# Access Compliance Report

## Public Rights-of-Way

### (Curb Ramps)

| Intersection ID: 14093 | Main Street: E_4TH_ST  | Cross Street: HAWTHORNE_LN | Location: S            |

| ADA ID: 453D60DE0F91   | Ramp Type: BlendTrans1 | Initial Pass/Fail: Fail    | Overall Compliance: No |

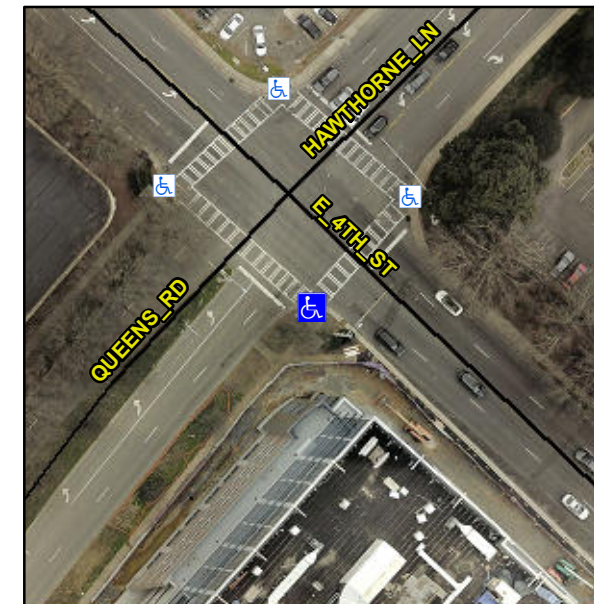
**Not Found, R304.5.1, R304.5.3**

| Compliance | Description           | Data  | Compliance | Description                 | Data  |
|------------|-----------------------|-------|------------|-----------------------------|-------|
| No         | Ramp Width (in)       | 44.0  | No         | BlendTrans XSlope (%)       | 6.0   |
|            |                       |       | No         | Curb Slope (%)              | 11.2  |

**Remove & Replace Curb Ramp With Two New Directional Ramps or Equivalent.**
